TOWN OF NEWBURGH
PLANNING BOARD
TECHNICAL REVIEW COMMENTS

PROJECT:	**MATRIX**
PROJECT NO.:	**15-26**
PROJECT LOCATION:	**SECTION 95, BLOCK 1, LOTS 4.12, 54.1, 69.25 & 49.12**
REVIEW DATE:	**17 NOVEMBER 2015**
MEETING DATE:	**19 NOVEMBER 2015**
PROJECT REPRESENTATIVE:	**LANGAN ENGINEER**

Re: Planning Board Technical Review Comments
Matrix Business Park at Newburgh
Newburgh, New York
Langan Project No.: 9190601

ENTRANCE DRIVEWAY PROFILE

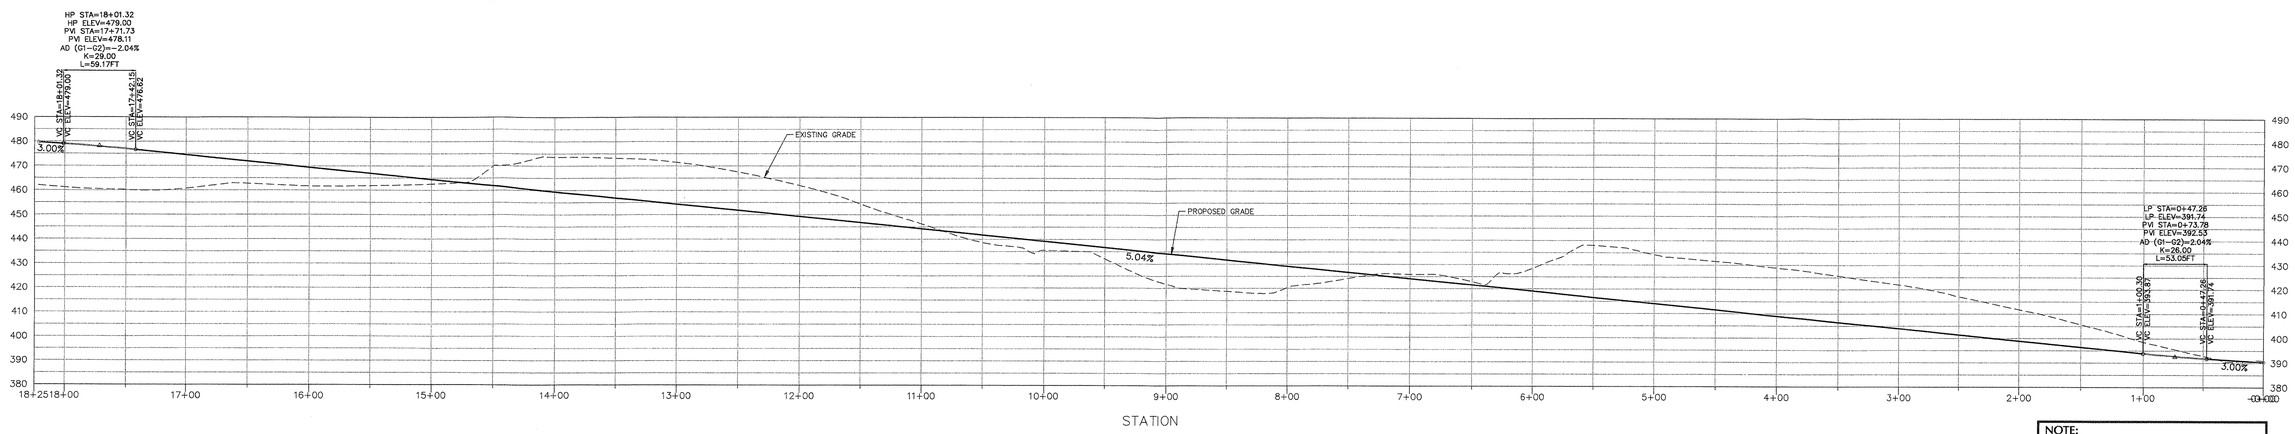
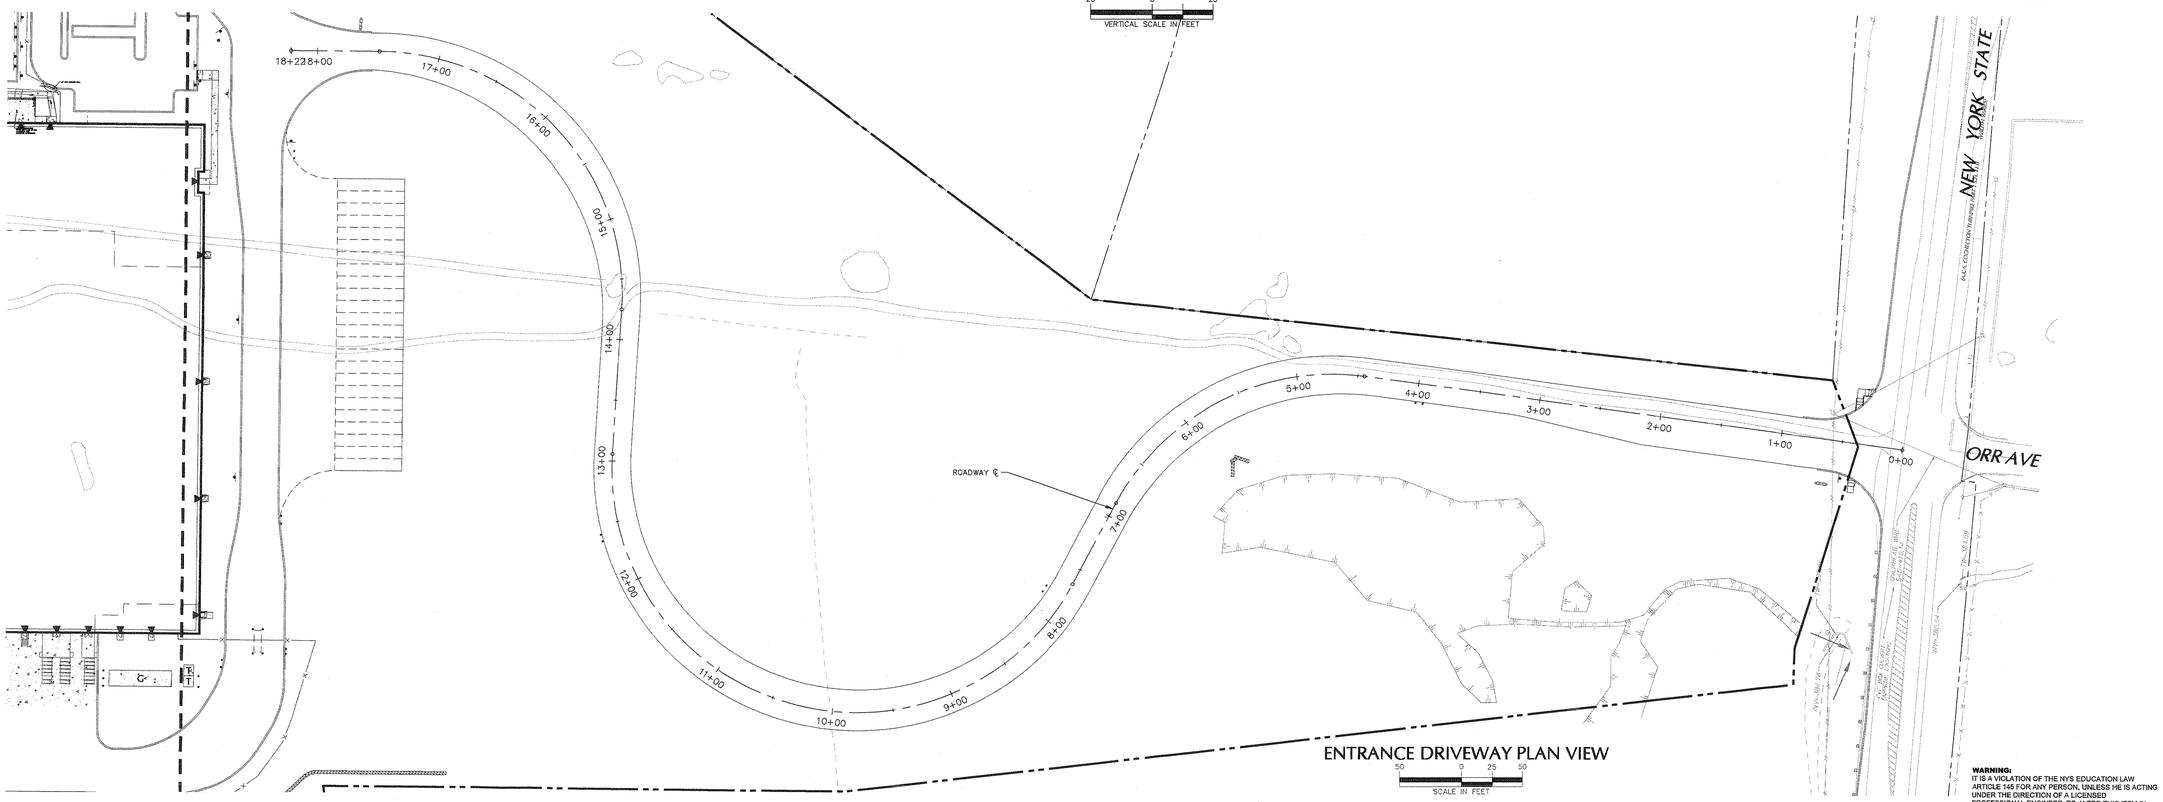
Comment 13: *Height of proposed access road lighting should be discussed with the Planning Board. 40 foot wooden light poles are depicted on the plans.*

Response 13: **We are proposing overhead primary electric service, as such Central Hudson and Gas requires 40 foot wooden poles for the service run along the entrance drive. The remaining light poles which do not carry primary electric service have been lowered to 35 feet and will have underground secondary service.**

TYPICAL SLOPE PHASING

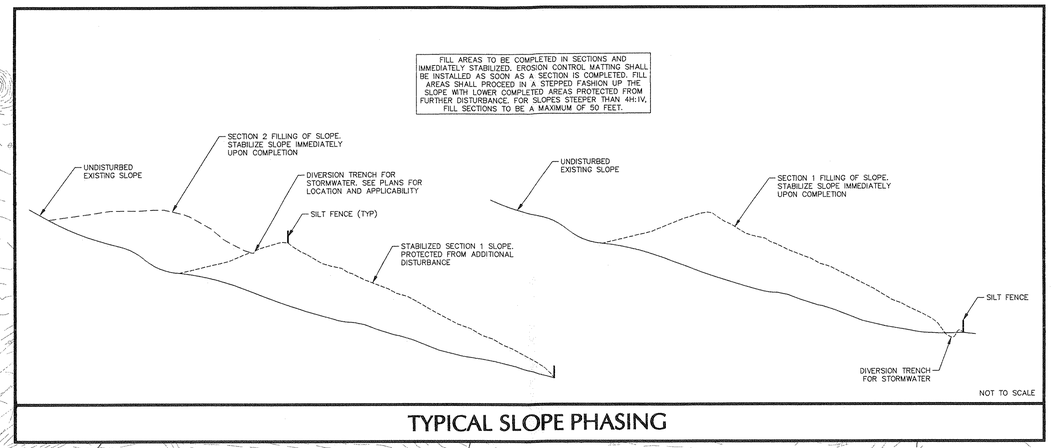
Comment 20: *Erosion and sediment control, as well as specialized construction techniques for the 100"'- foot slope along the easterly side of the project should be further detailed. Interim swales and a sediment trap are identified within the slope. No erosion and sediment control or storm water management is provided prior to discharge of the run off of the slope into the large federal jurisdictional wetland area along the eastern project boundary. Interim measures will be terminated prior to stabilization of the slope due to their location within the fill area.*

Response 20: **Further detail and design has been added to the soil erosion and sediment control plans and swppp to address these concerns.**
